Product Change Notification / SYST-21NWMU176

ERRATA - dsPIC33CH512MP508 Family Silicon Errata and Data Sheet Clarification

1. Update's silicon issue 26 (Secondary CPU).
2. Adds silicon issue 27 (SCCP).
3. Adds data sheet clarification 17 (Electrical Characteristics).

dsPIC33CH512MP508 Family Silicon Errata and Data Sheet Clarification

FIGURE 1-1: I/O RAMP

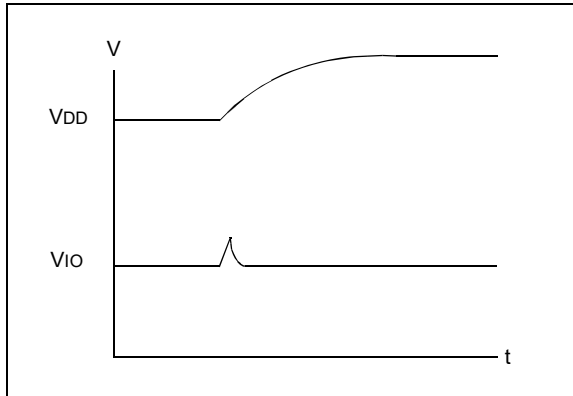
During a fast device power-up, when the VDD ramp is less than 4 mS, the I/O pins may drive up to 100 μ A current for a duration of up to 10 μ S (Figure 1-1).

1. Slow down the VDD ramp time (greater than 4 mS for VDD to ramp 0V to 3.3V).
2. Ensure the circuitry that is connected to the pins can endure this pulse.

Example applications affected may include complementary power switches, where a transient current shoot-through might occur. High-voltage applications with complementary switches should power the high-voltage 200 μ Sec later than powering the dsPIC[®] device to avoid the current shoot-through. This behavior is specific to each device and not affected by aging.

FIGURE 2-2: SUGGESTED PLACEMENT OF THE OSCILLATOR CIRCUIT

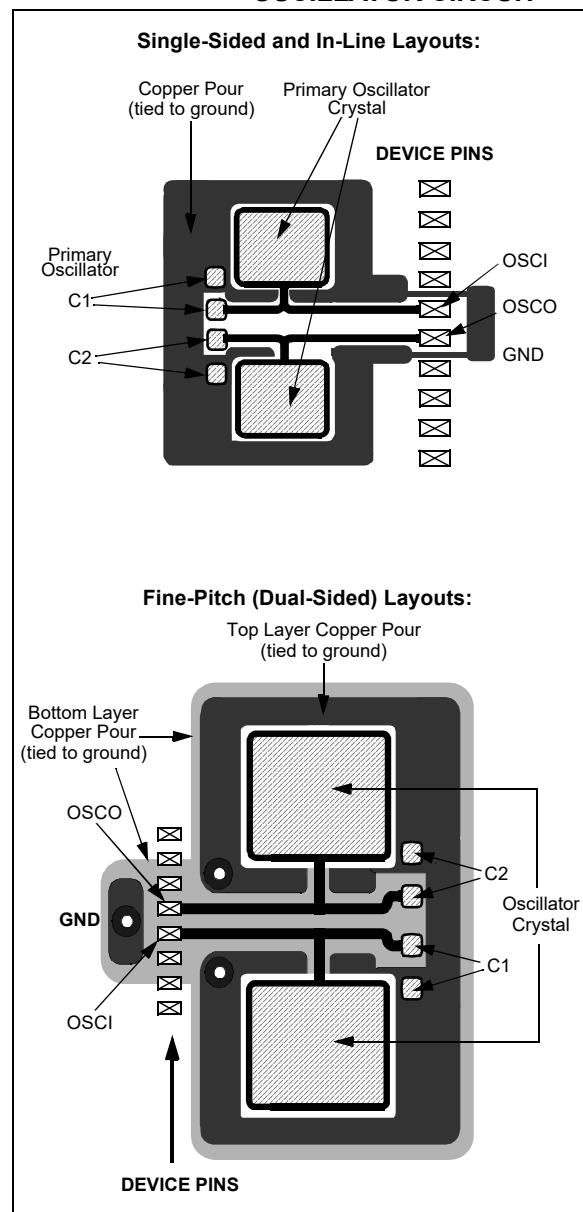
Additional information is added to [Section 2.5 “External Oscillator Pins”](#) and [Section 2.6 “External Oscillator Layout Guidance”](#) is added.

Use best practices during PCB layout to ensure robust start-up and operation. The oscillator circuit should be placed on the same side of the board as the device. Also, place the oscillator circuit close to the respective oscillator pins, not exceeding one-half inch (12 mm) distance between them. The load capacitors should be placed next to the oscillator itself, on the same side of the board. Use a grounded copper pour around the oscillator circuit to isolate it from surrounding circuits. The grounded copper pour should be routed directly to the MCU ground. Do not run any signal traces or power traces inside the ground pour. If using a two-sided board, avoid any traces on the other side of the board where the crystal is placed. Suggested layouts are shown in [Figure 2-2](#). With fine-pitch packages, it is not always possible to completely surround the pins and components. A suit-

able solution is to tie the broken guard sections to a mirrored ground layer. In all cases, the guard trace(s) must be returned to ground.

FIGURE: ADC ANALOG INPUT MODEL

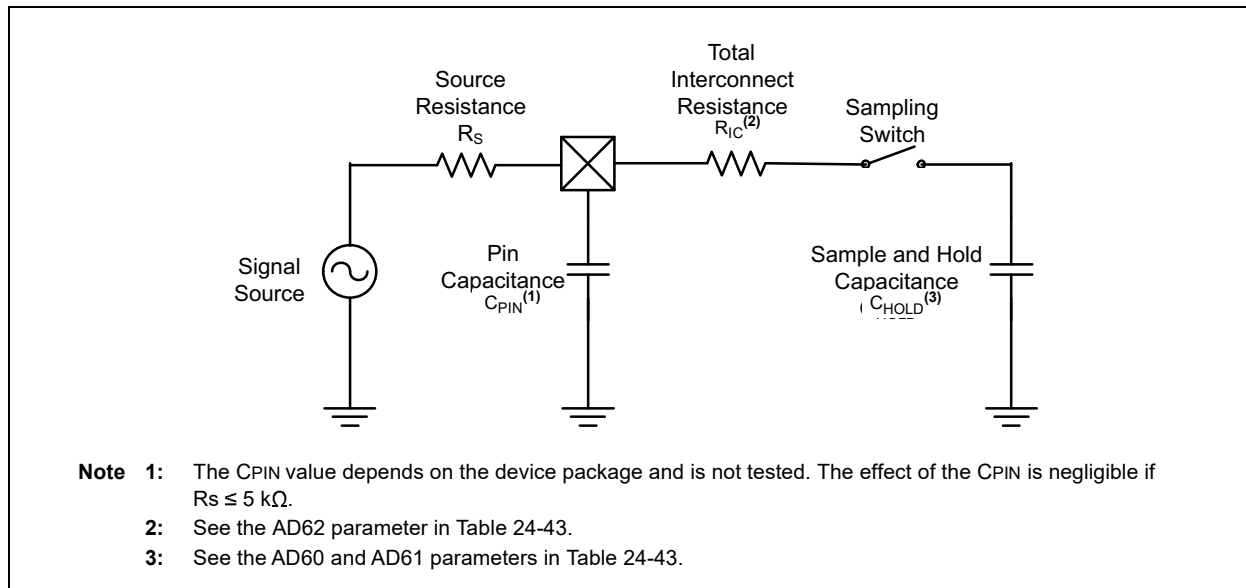
The following [Sampling Time Requirements](#) section has been added to both [Section 3.16 “High-Speed, 12-Bit Analog-to-Digital Converter \(Main Core ADC\)”](#) and [Section 4.7 “High-Speed, 12-Bit Analog-to-Digital Converter \(Secondary Core ADC\)”](#).

The analog input model of the ADC is shown in the figure below.

The total acquisition time for the Analog-to-Digital conversion is a function of the Holding Capacitor (C_{HOLD}) charge time. For the ADC module to meet its specified accuracy, the Holding Capacitor (C_{HOLD}) must be allowed to fully charge to the voltage level on the analog input pin. The Signal Source Impedance (R_S) and the Interconnect Impedance (R_{IC}) combine to affect the time required to charge the C_{HOLD} . The total resistance ($R_S + R_{IC}$) must therefore, be small enough to fully charge the Holding Capacitor within the selected sample time.

FIGURE 21-4: FLASH SECURITY SEGMENTS (SINGLE PARTITION MODE)

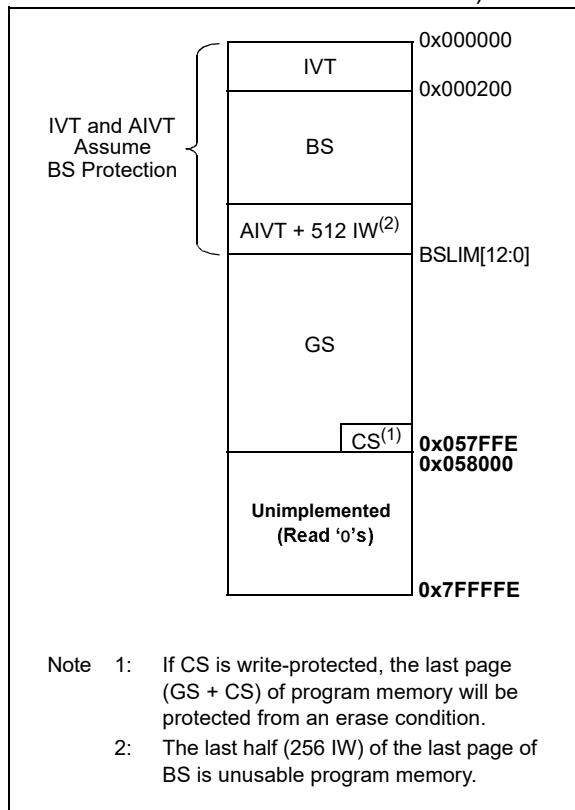
Figure 21-4 has been updated as shown in **bold** below.

FIGURE 21-5: FLASH SECURITY SEGMENTS (DUAL PARTITION MODE)

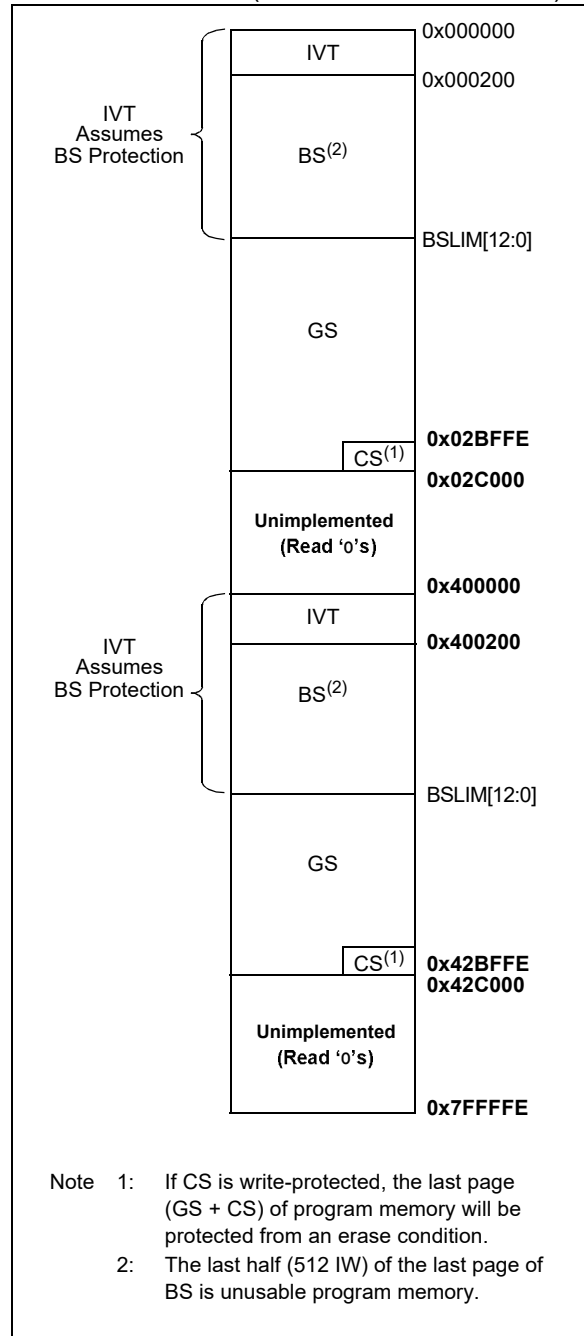
Figure 21-5 has been updated as shown in **bold** below.

FIGURE 4-3: PRAM (PROGRAM MEMORY) FOR SECONDARY CORE dsPIC33CH512MP508S1 DEVICES

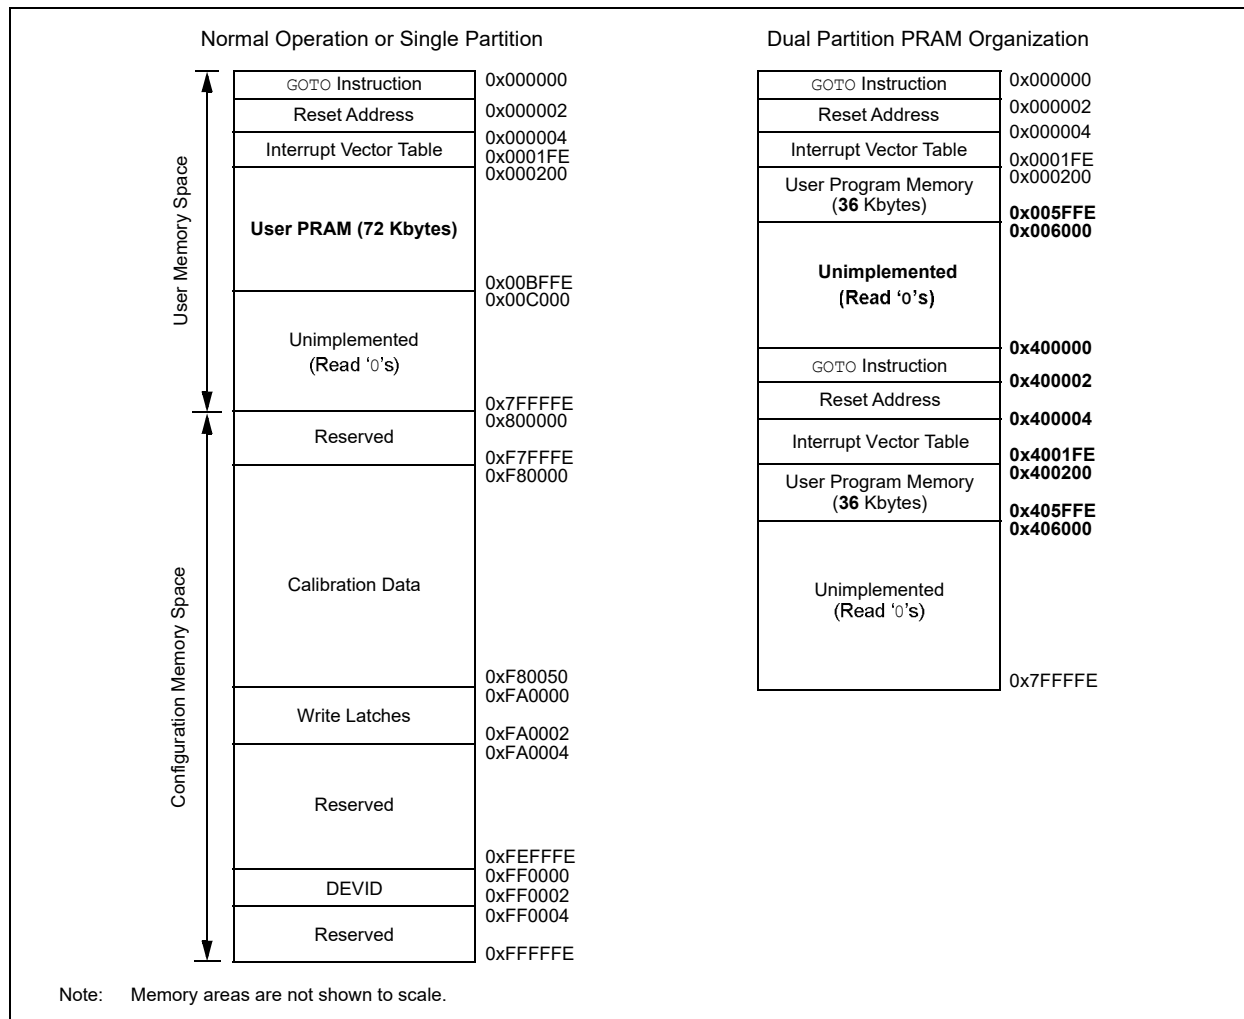
Figure 4-3 has been updated as shown in **bold** below.
